NABCO ENTRANCES TECHNICAL BULLETIN

Change to Sprocket Retaining Screw on GT-710 Operator

Bulletin Number: **49**

Current Design
(underside of operator assy. shown)

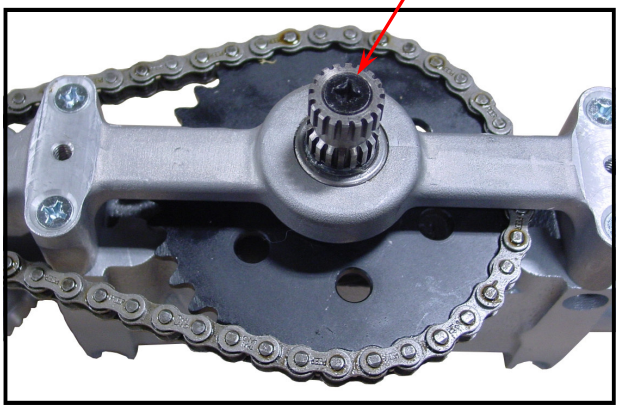
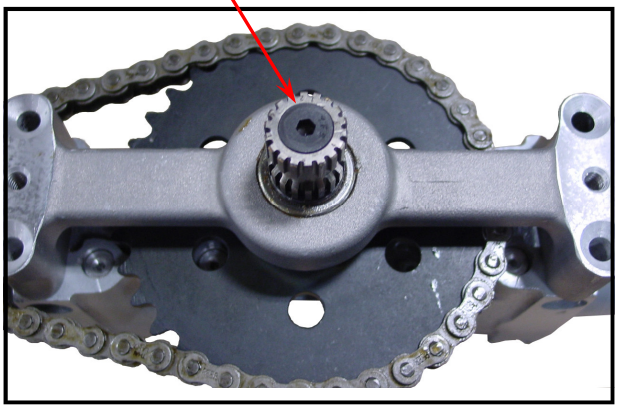
Refer to the illustrations below. The Phillips head screw, part number 24-0011-114, that is used to secure the large sprocket to the hydraulic closer on the GT-710 operator will be upgraded to a higher grade fastener. The new improved fastener will have an Allen hex head. The part number will remain the same.

The changeover to the new Allen hex head type screw will occur around mid March 2011.

Allen Hex Head Screw - 5/32” Allen Wrench

Design Effective Mid March 2011
(underside of operator assy. shown)
